**Planning Board Meeting Agenda
Brunswick Town Hall
85 Union Street – Council Chambers
Tuesday, February 10, 2026 @ 6:00 PM**

DRAFT FINDINGS OF FACT SITE PLAN AMENDMENT PLANNING BOARD

MAINEHEALTH
MID COAST CANCER CENTER RENOVATION
81 Medical Center Drive
Brunswick, ME 04011

A4.01
ELEVATIONS-
EXTERIOR- BUILDING

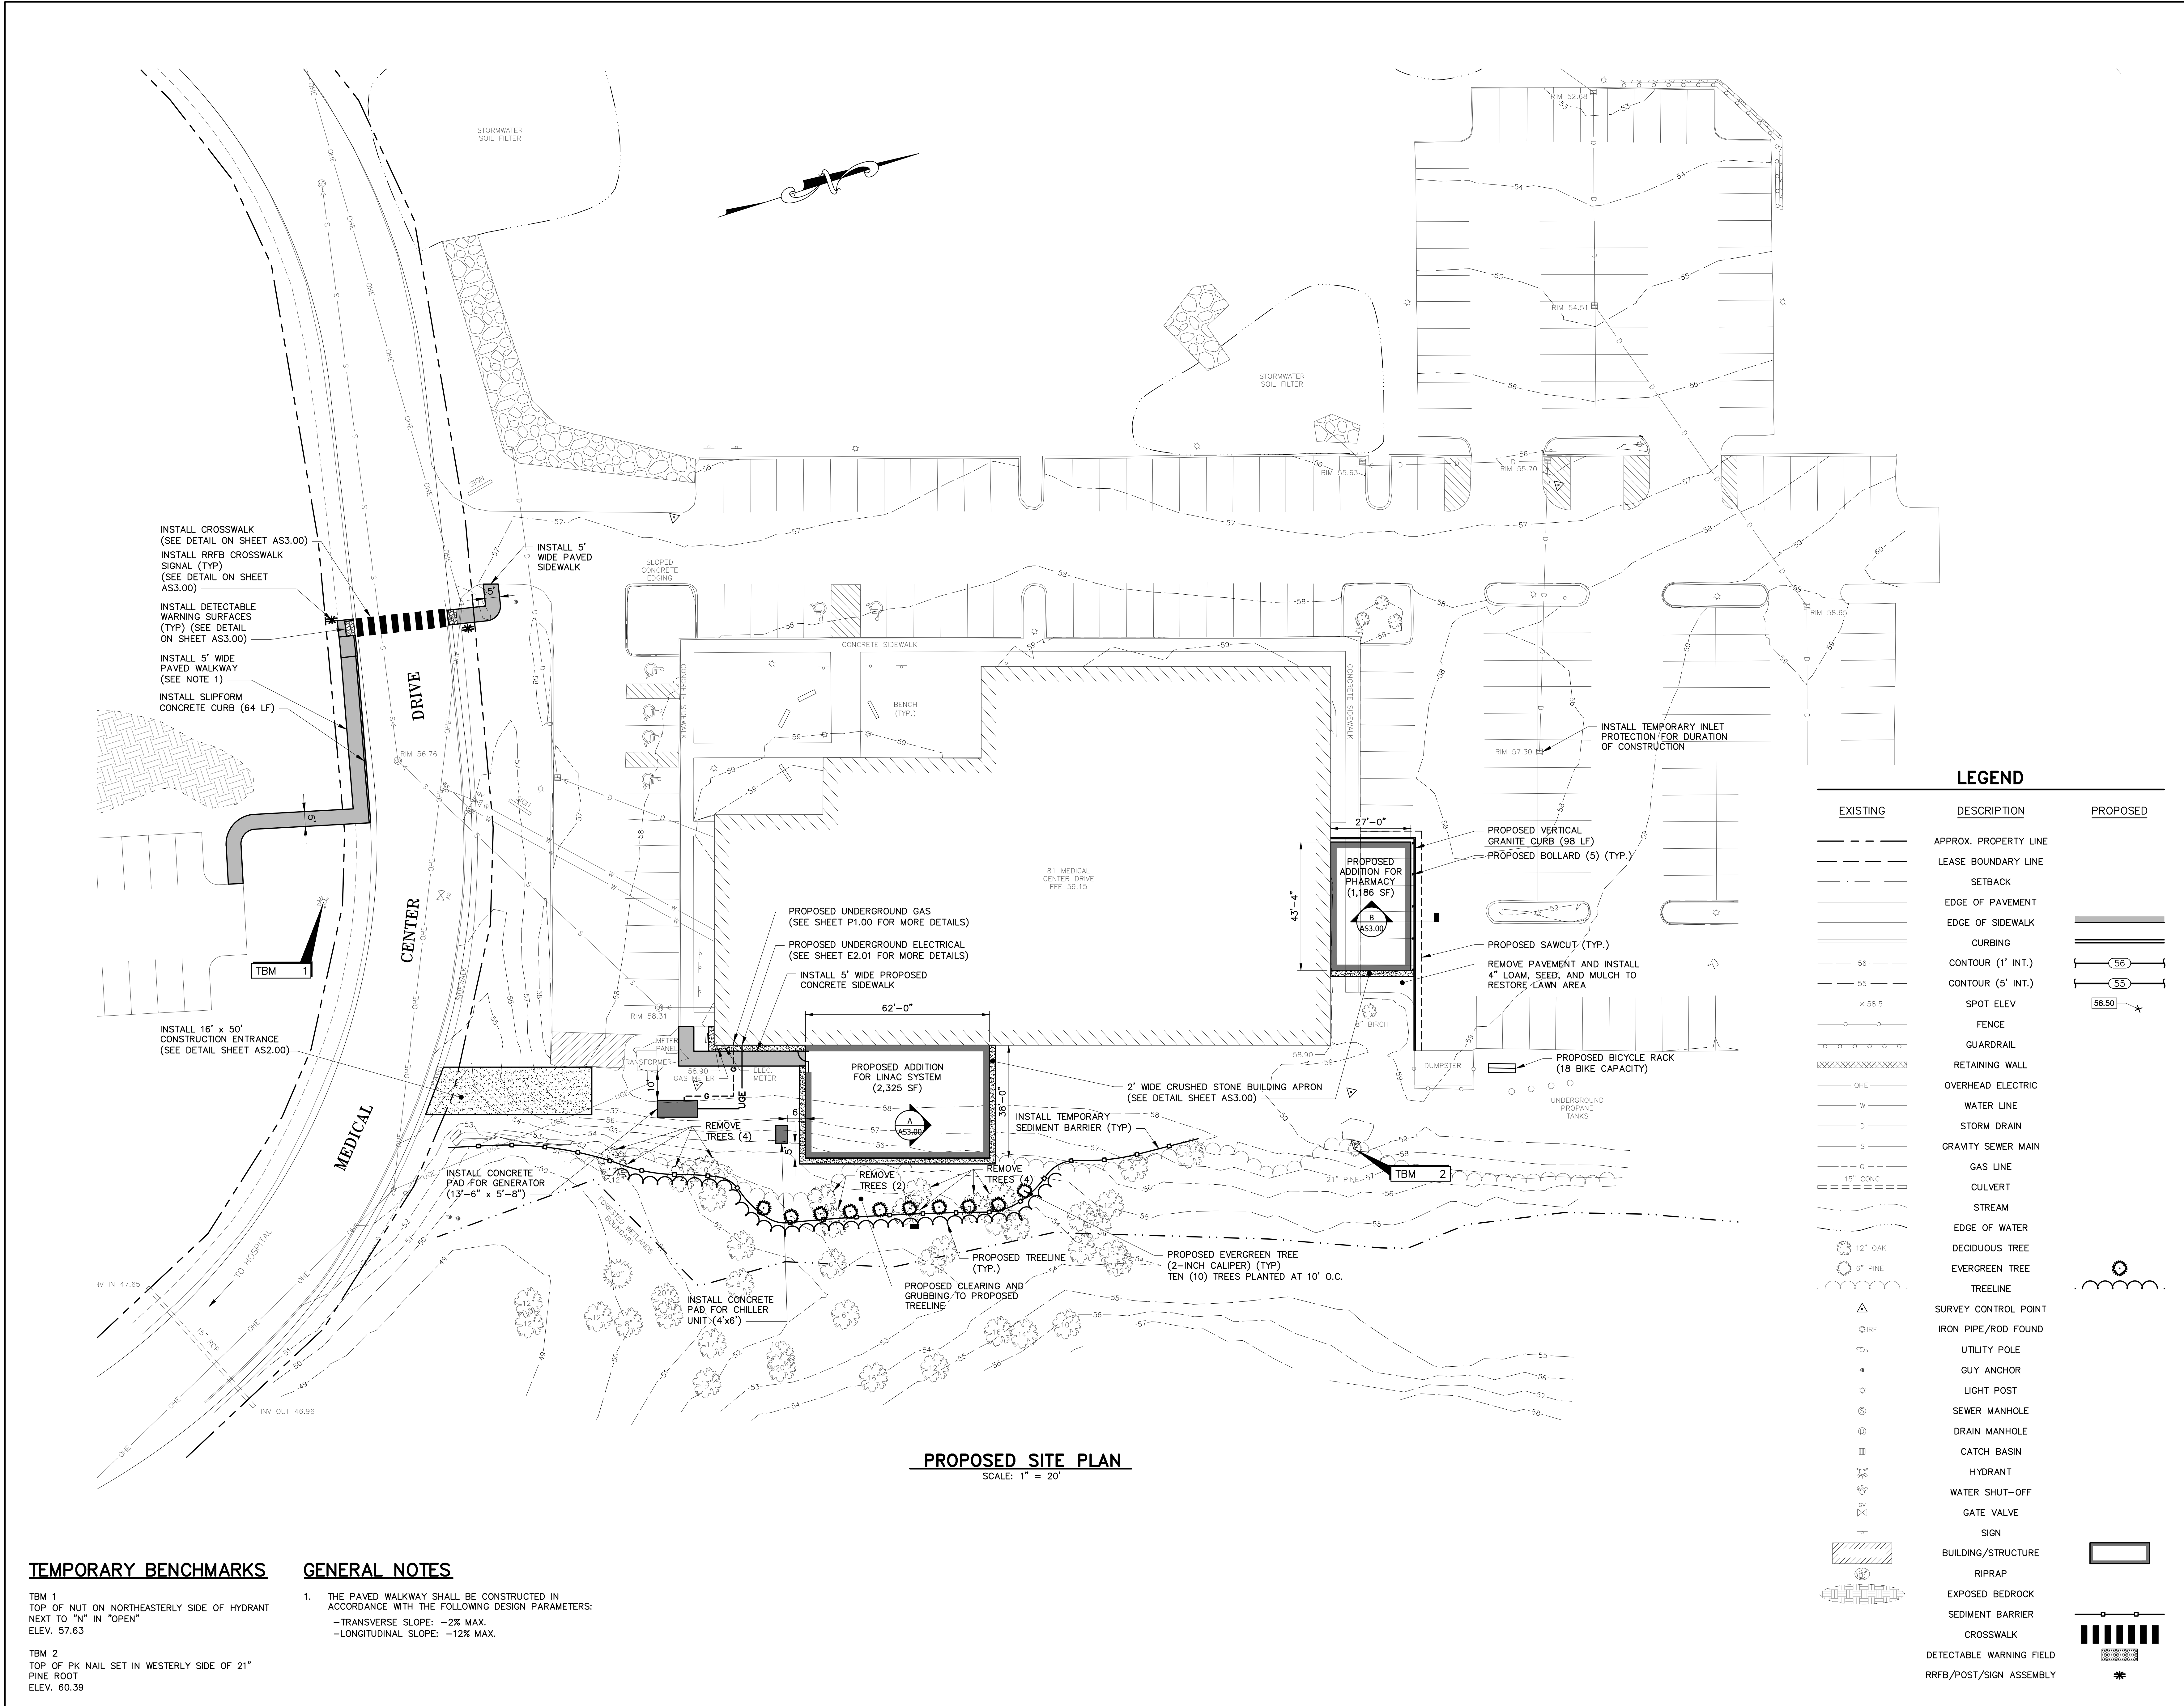
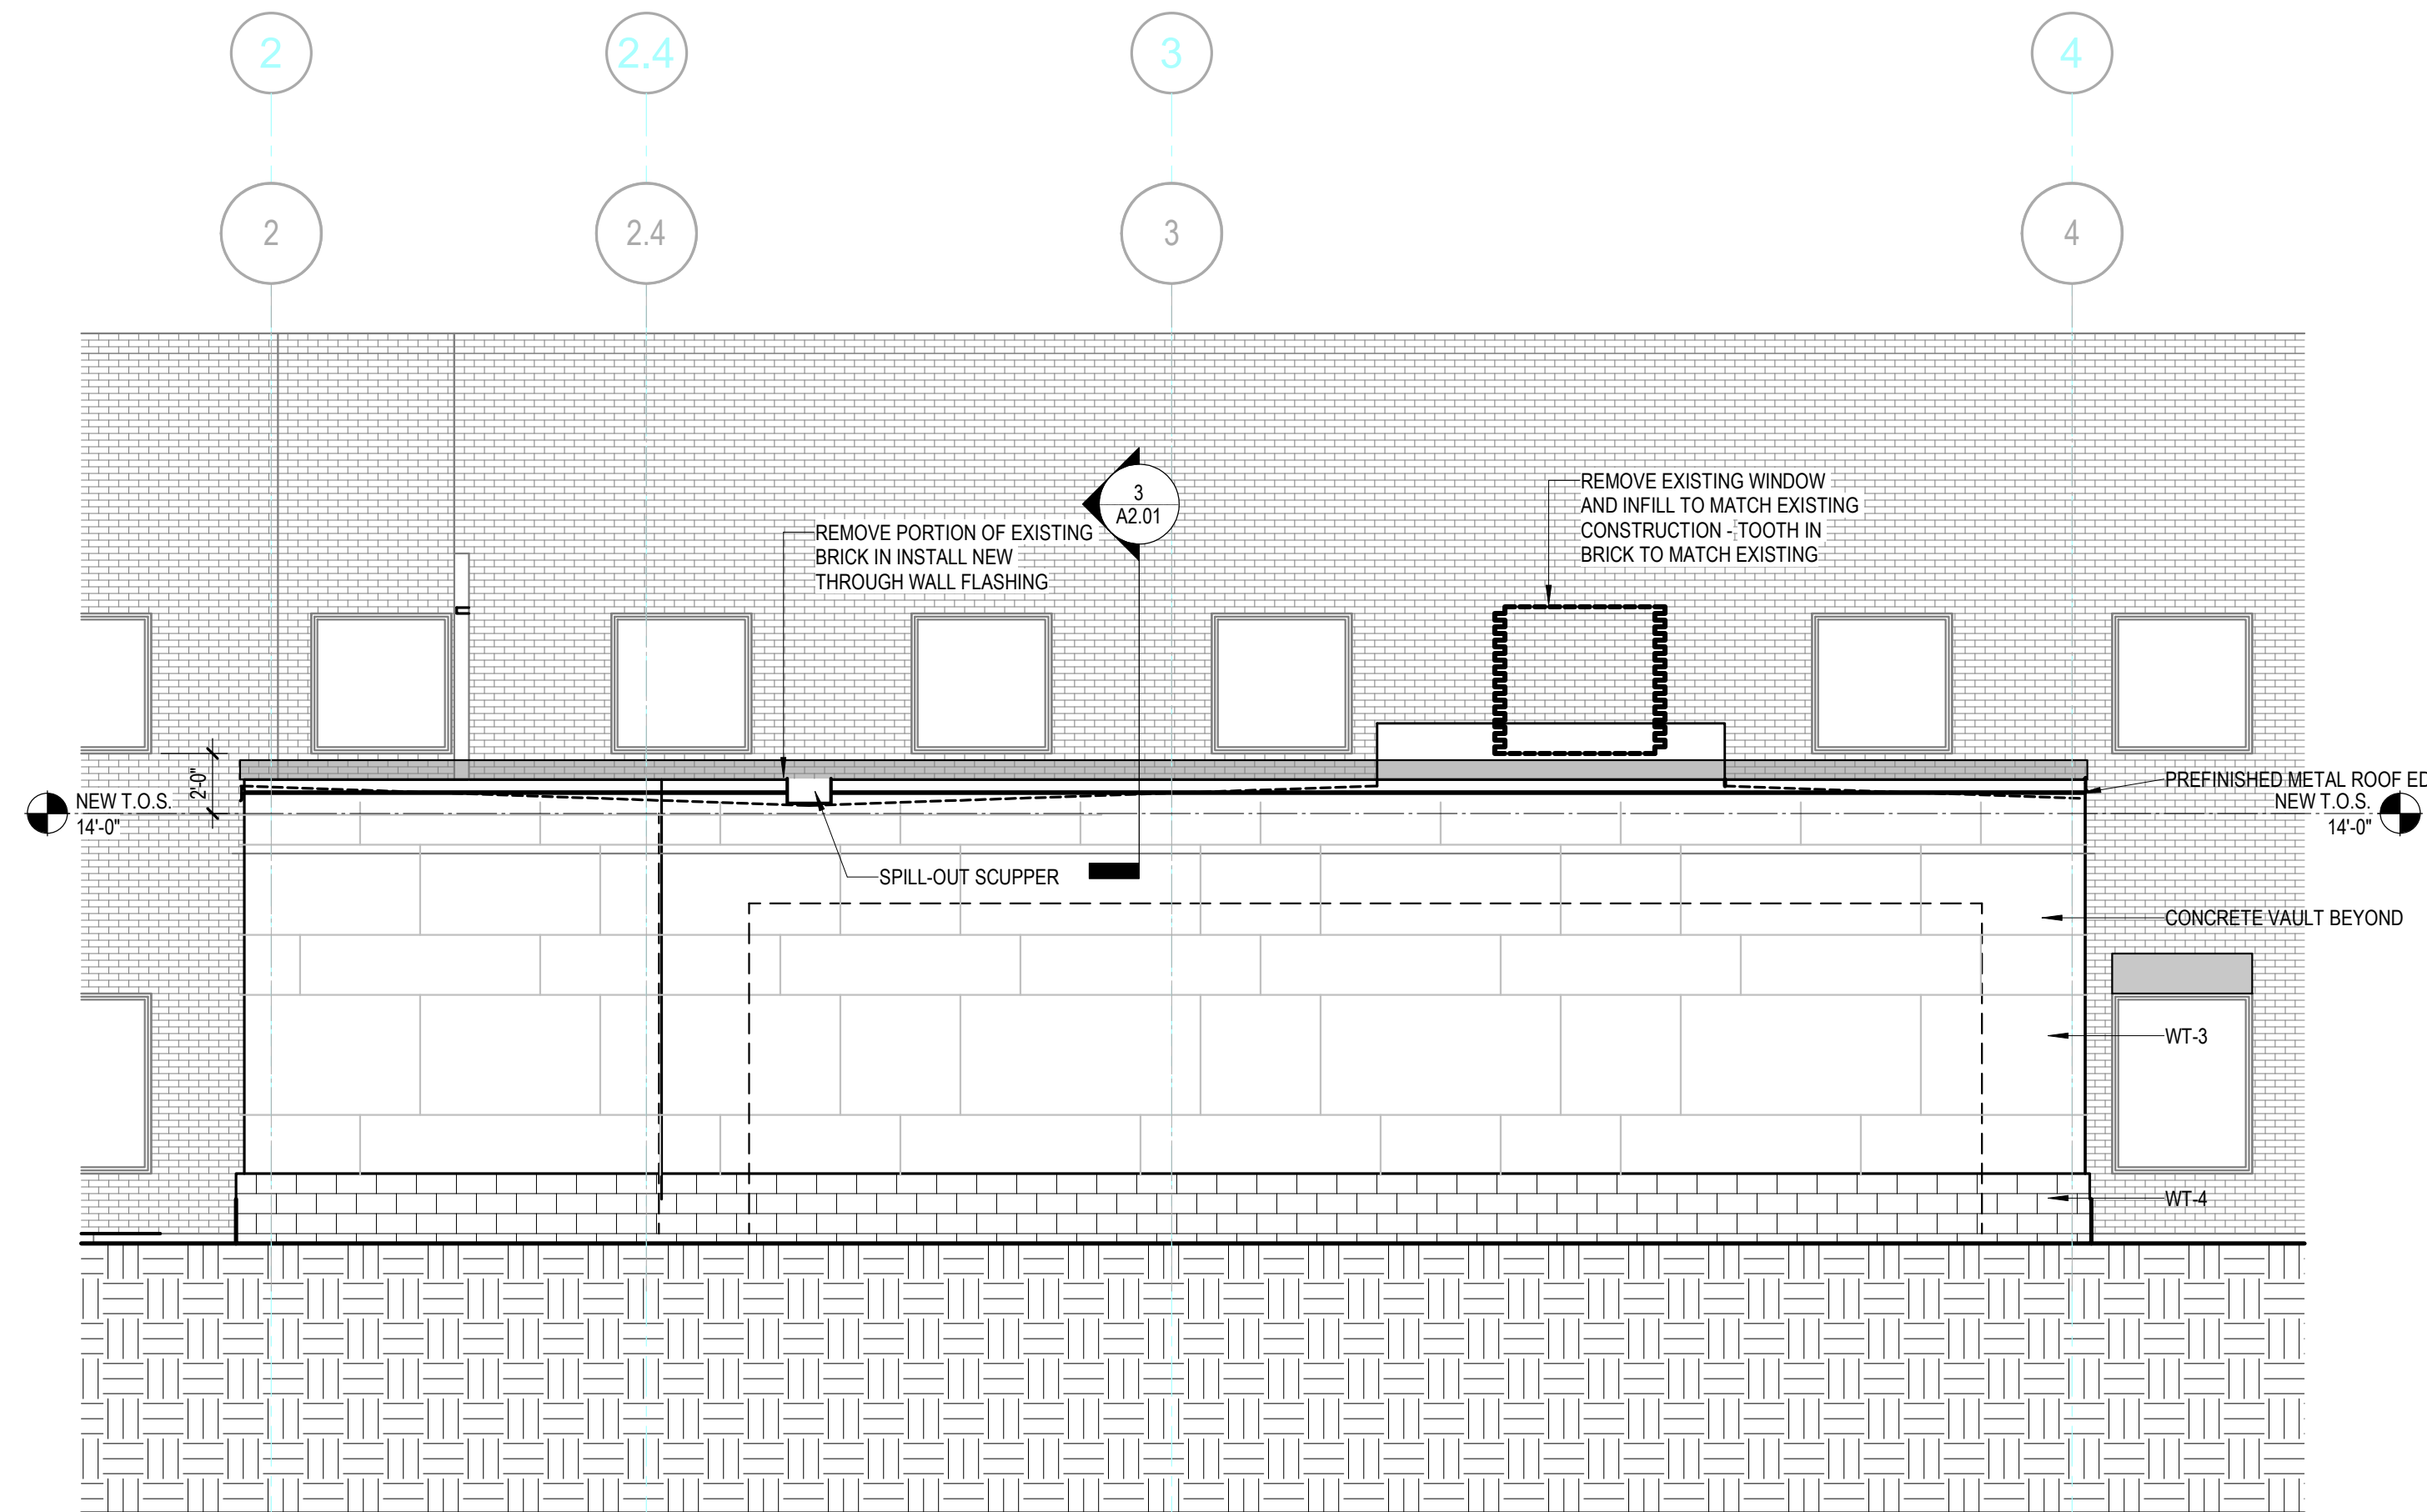
3.4 J Windowless circumstances says, "buildings without windows, i.e. a computer, a server building or self-storage buildings, shall incorporate a change in scale and siding materials instead of windows to create a sense of rhythm and cadence to create human scale. These material scale changes shall be demonstrably compatible with the scale and cadence of adjacent building facade treatments". The LINAC part of the building is towards the back, but the pharmacy faces a parking lot, so that is a little bit human facing.

3. Add ornamental grass along parking lot side of pharmacy, near bollards	See Section B-B on AS3.00 Civil Details
Architecture Comments	
4. Review Cooks Corner Design Standards, specifically Section 3.4 Façade Requirements, and within 3.4.j.	See Exhibit 8: Cook's Corner Design Standards Narrative.
Engineering Comments

The two additions to 81 medical center drive are secondary facades according to the definition in Section 3.4 Façade Requirements item C.
